RESPONSES TO COMMENTS RECEIVED

**Cleveland Massillon Road
Improvement Project**

SUM-Cleveland Massillon Rd PID 103293

**City of Fairlawn and Copley Township,
Summit County, Ohio**

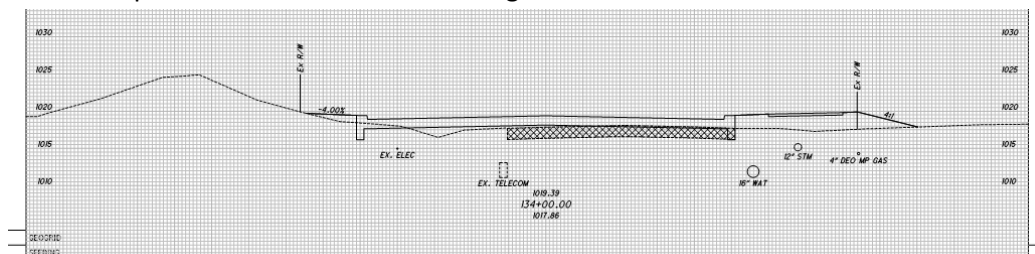
2. The Siamese Hydrant also appears to be in the way of the repositioning of Rothrock Road. We would appreciate it if the relocated hydrant be at the proper height from the ground so that we avoid the "mounding" situation that is currently needed.

Response: The Siamese Hydrant will be relocated and the contractor will be responsible for installing it at the proper height. The current mounding situation should be eliminated.
